Application of Rockhaven Homes LLC c/o Battle Law, P.C. to rezone from R-100 (Residential Medium Lot-100) to RSM (Small Lot Residential Mix) Zoning District to allow the construction of single-family detached homes, at 2717 Whitfield Road.

PETITION NO.: Z-22-1245310 (2021-3516)

STAFF ANALYSIS

SUBSTITUTE

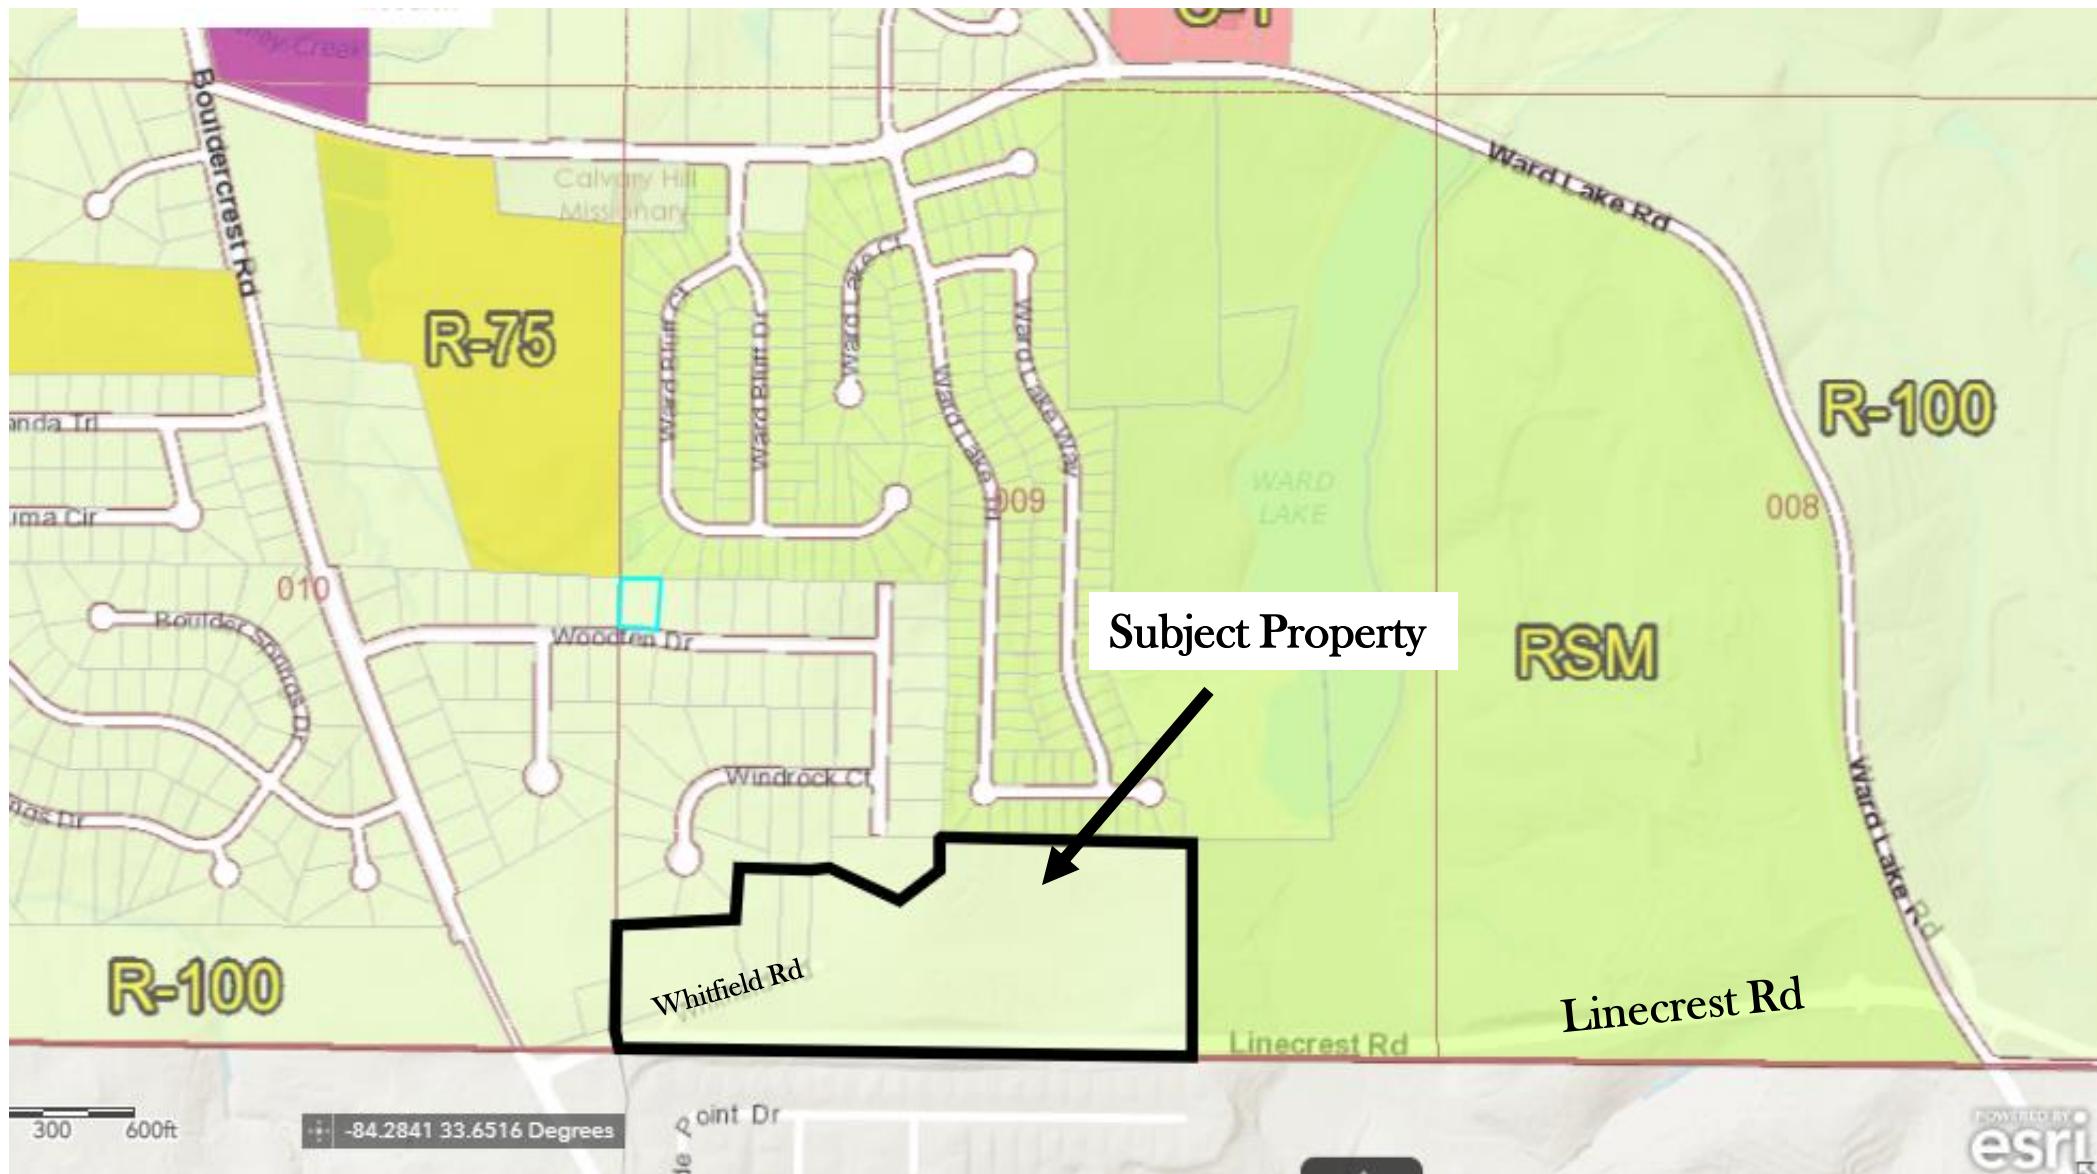
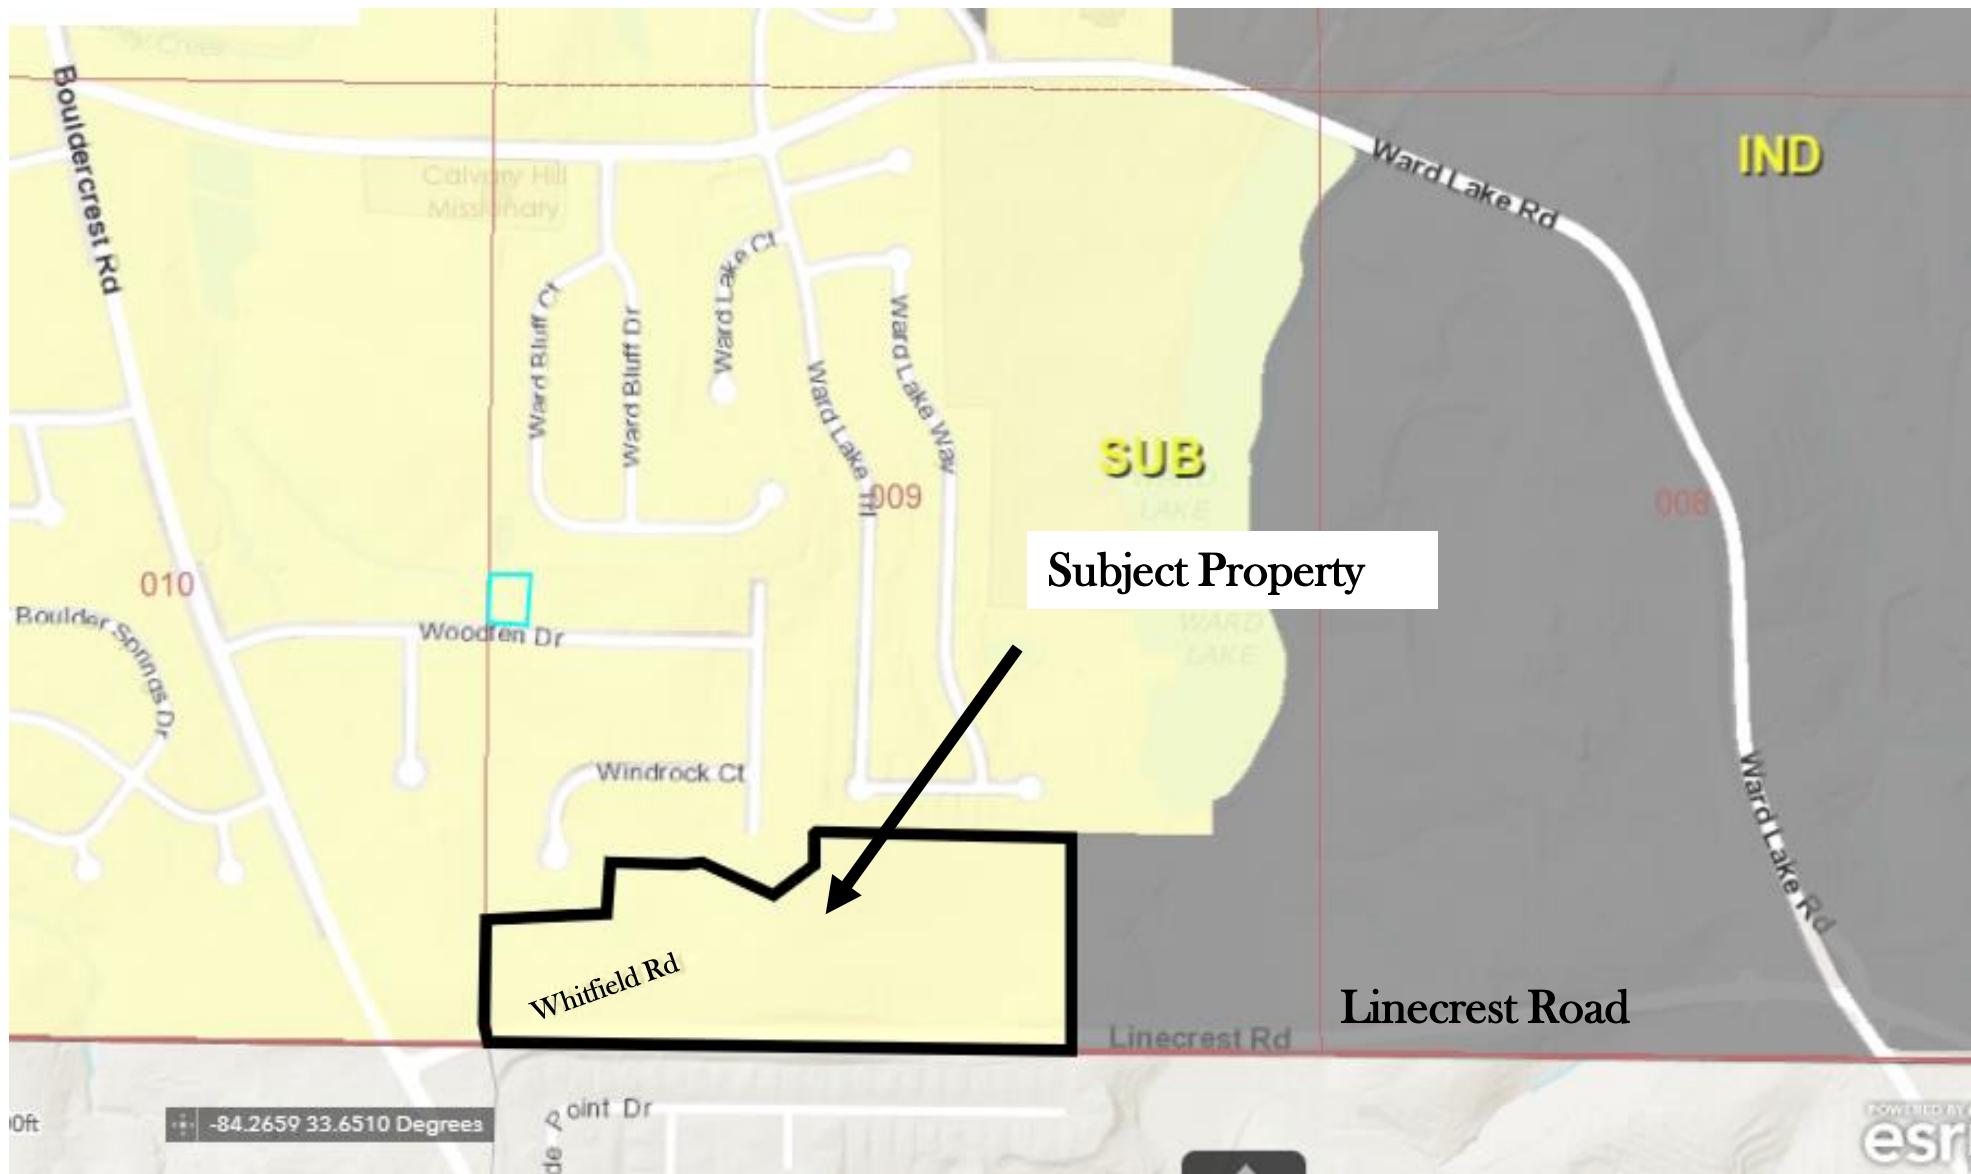
Plans and field reviewed. Nothing found that would disrupt traffic pattern flow.
